LOS ANGELES
CITY PLANNING

SUBJECT: Comments on the April 16, 2020 Draft Environmental Impact Report for proposed “Hollywood Center” project. State Clearinghouse Number SCH 2018051002.

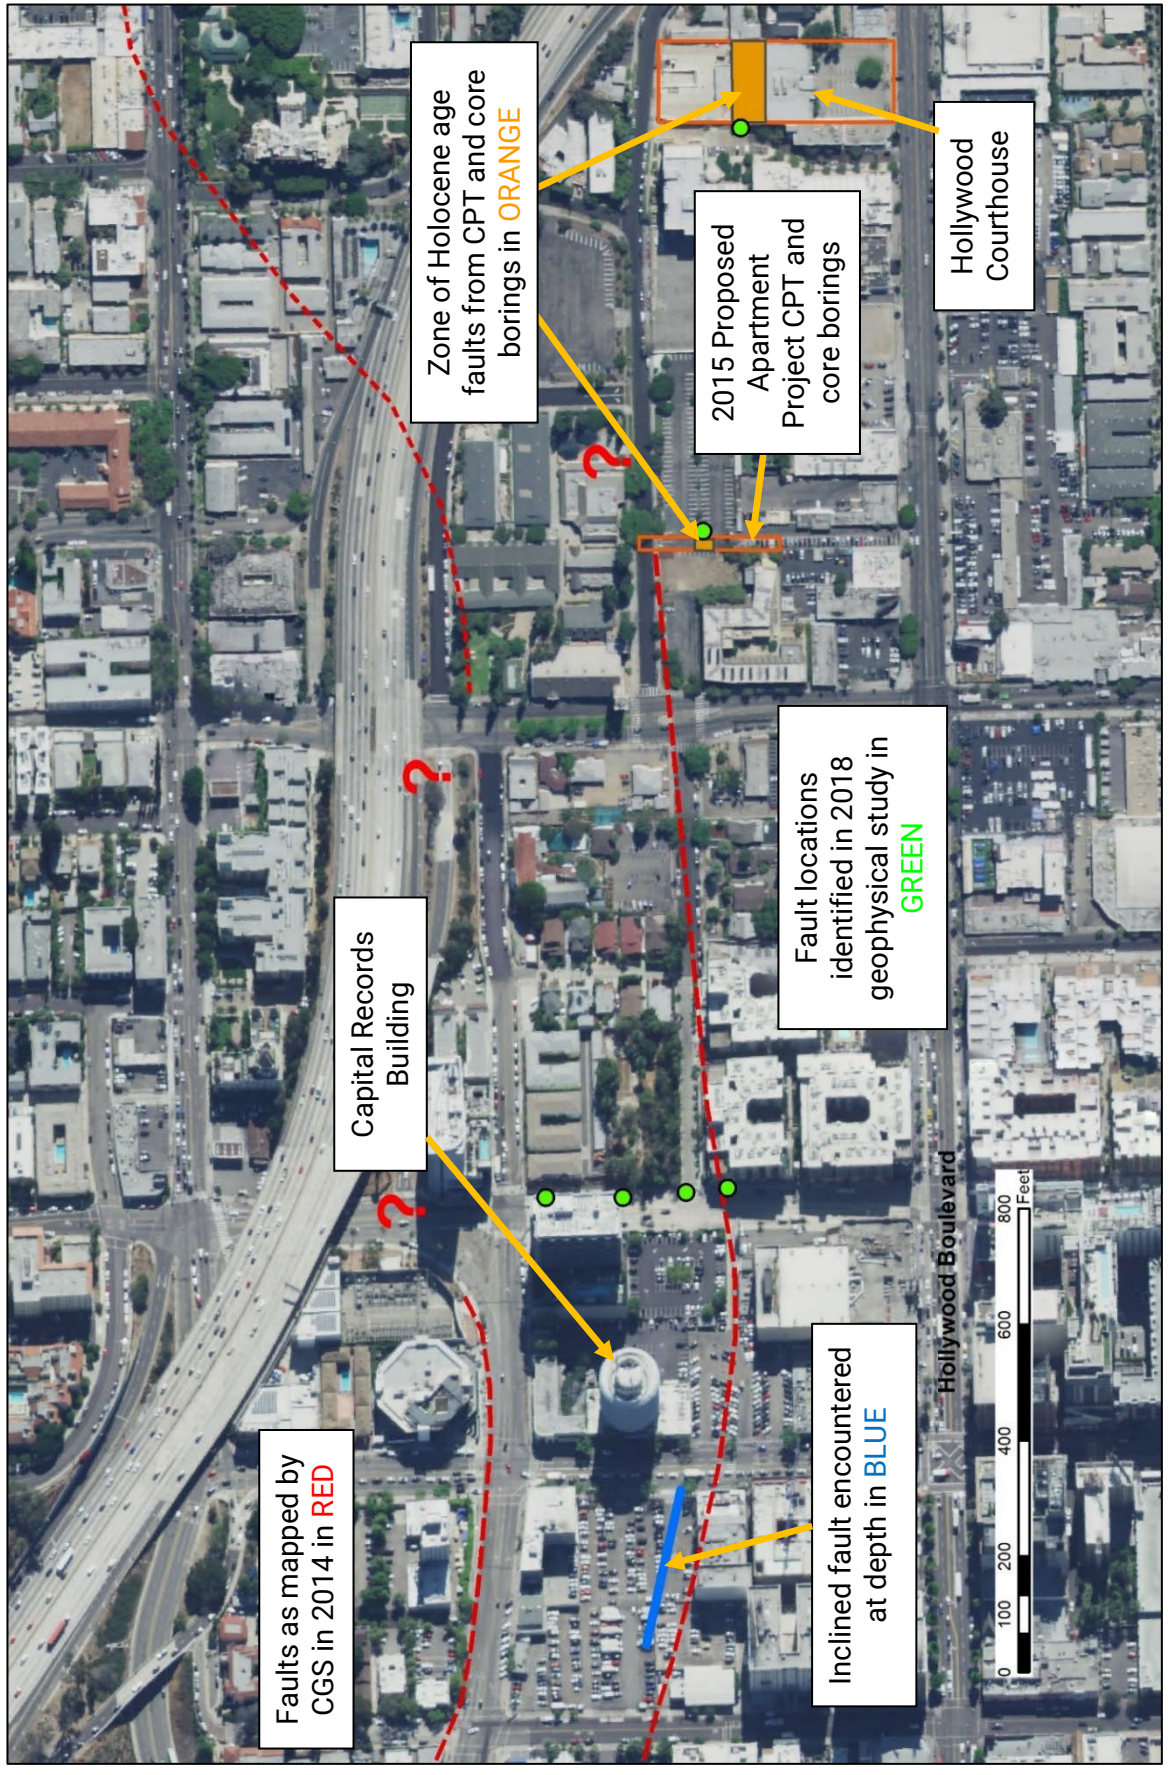
- 1. Fault traces depicted in CGS's 2014 Hollywood Fault Map do not appear in Appendix G-1's figures of the project site** where locations of their subsurface investigations are presented. Therefore, we attach a figure showing both the location of traces as shown on the 2014 Hollywood Fault Map and the areas of investigation reported in Appendix G-1 (**Figure 1**). (DEIR Appendix G-2 shows the location of the fault trace at a lower level of resolution.) We note below that Figure 1 reflects new information indicating the active fault, which was not cleared by either the 2014 trench or the other investigative techniques reflected in Appendix G-1.

- 2. The 2020 USGS study, and other studies that post-date CGS's 2014 Hollywood Fault Map, strongly suggest an active strand of the fault crosses the project site.** CGS considered the 2020 USGS study in light of other studies conducted after the 2014 Hollywood Fault Map. These studies are listed at the end of this letter and, for your convenience, are also available on CGS' FTP server ([FTP Link](#)). These studies, conducted east of the project site, postdate the studies included as Appendix G-1 to the DEIR, and are therefore new information of importance to public safety. These studies strongly support the presence of an active southern fault strand entering the eastern Hollywood Center property in the vicinity of the alley at Argyle, south of the

3. **The fault trench excavated in 2014 did not clear the entire site of active faults.** Based upon review of the information presented in Appendix G-1 of the DEIR, the GDC trench on the east property did not completely expose the base of the Holocene-age geologic section across the north-south extent of the site and therefore cannot be considered to exclude the presence of an active fault at or near where it is depicted in CGS's 2014 Hollywood Fault Map, or in the more recent studies mentioned above.
